REMARKS

Annotated Marked Up Drawings

Application Serial No. 10/826,197

Title: CLOCK DOUBLER

FIG. 1

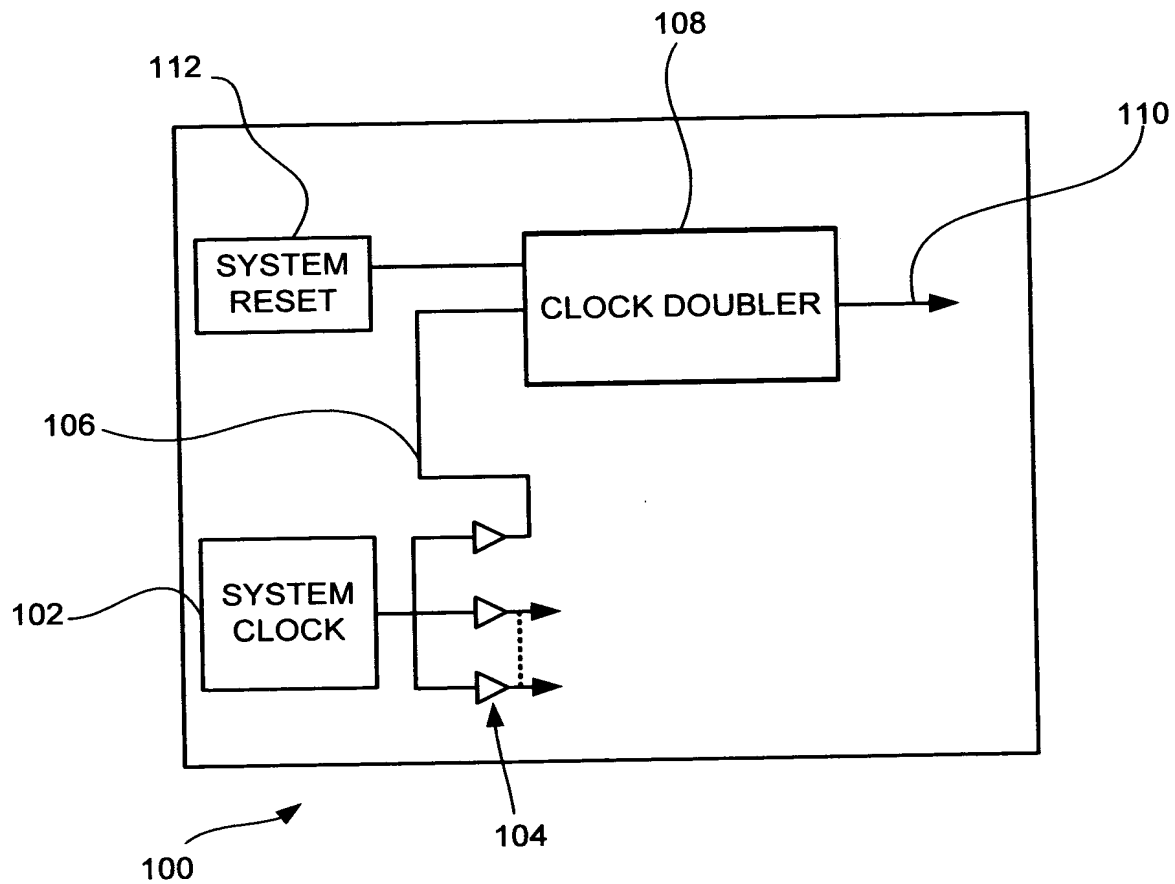
The Examiner has objected to the drawings because all black boxes in FIG. 1 need text labels; the timing circuitry 260 is not labeled in FIG. 2; and the Examiner cannot determine which elements of the drawings form the timing circuitry 255 and 260 due to unclear labeling.

"all black boxes in Fig. 1 need text labels"

Nonetheless, Applicant has amended FIG. 1 to provide text labels in the interest of moving prosecution forward. Accordingly, Applicant respectfully submits that this objection has been overcome. Withdrawal of this objection is warranted, and such action is hereby solicited.

FIG. 2

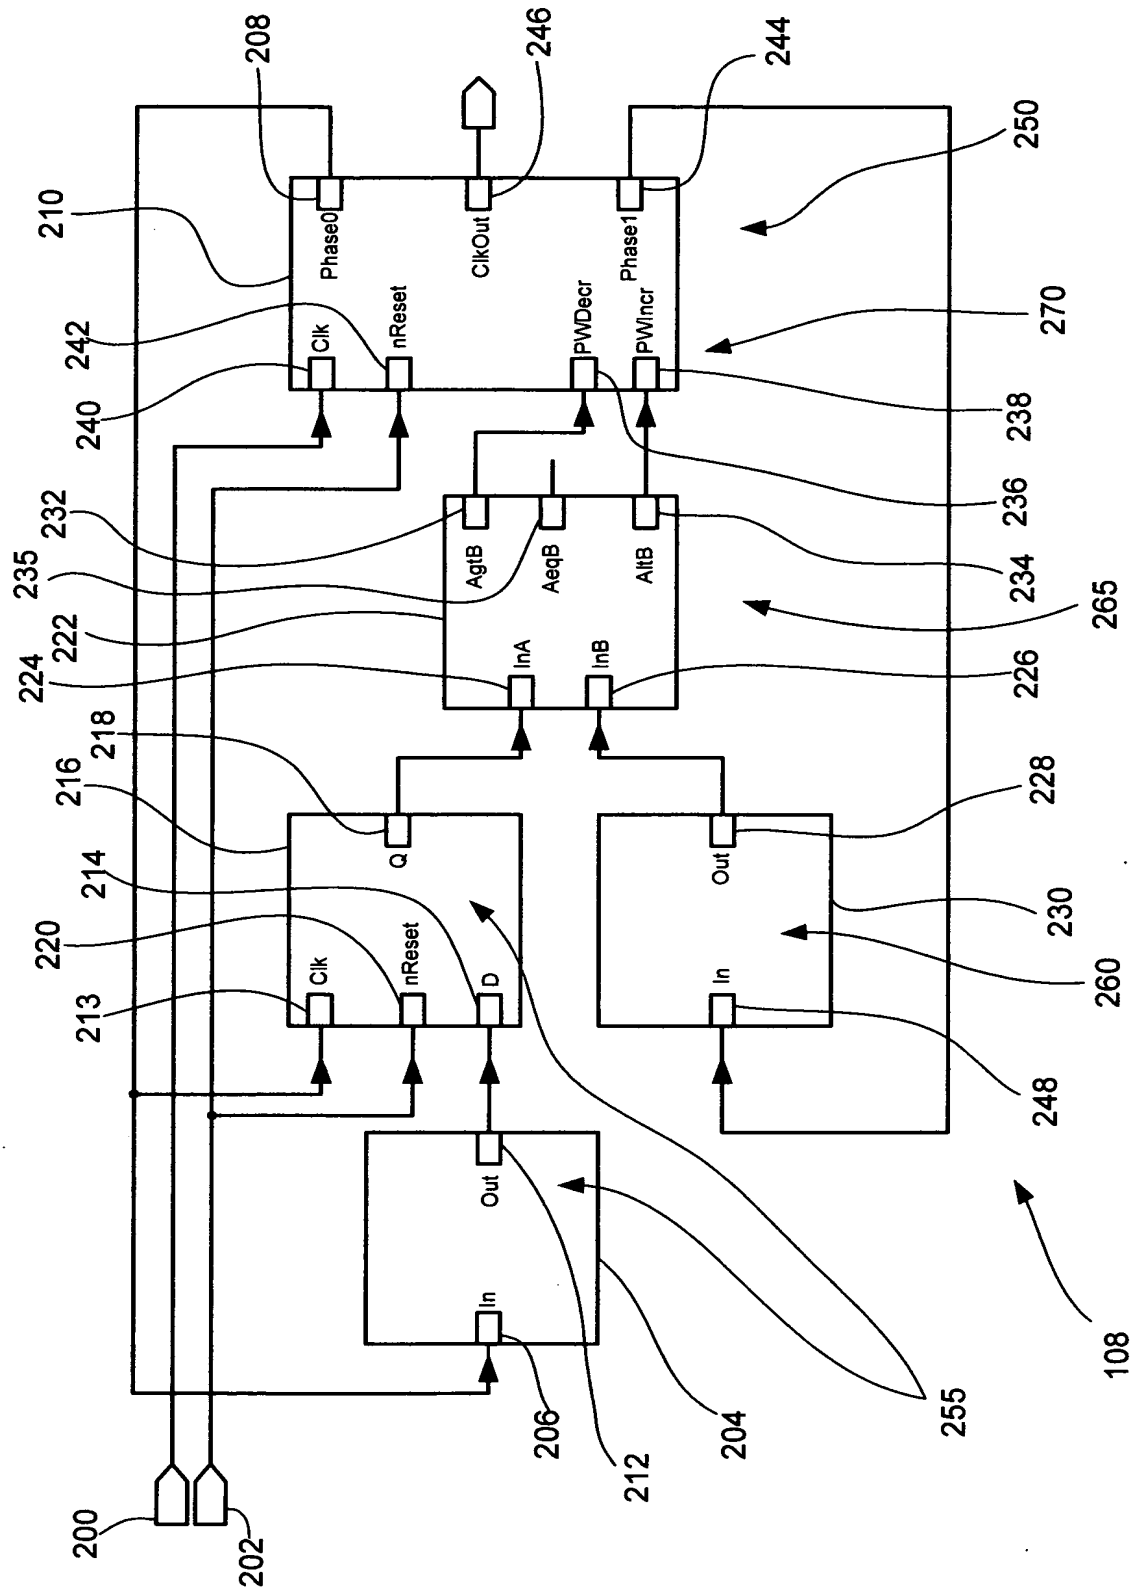
“With respect to claim 1 line 10, the recited "tap delay line for delaying the system clock" is unclear because the tap delay line (Figure 2, 204) does not receive the system clock (Figure 2, 200).

“the Examiner cannot determine which elements of the drawings form the timing circuitry 255 and 260”

FIG. 2 has been amended to clarify which elements of FIG. 2 form the timing circuitry 255 and 260. Accordingly, Applicant respectfully submits that this objection has been overcome. Withdrawal of this objection is warranted, and such action is hereby solicited.
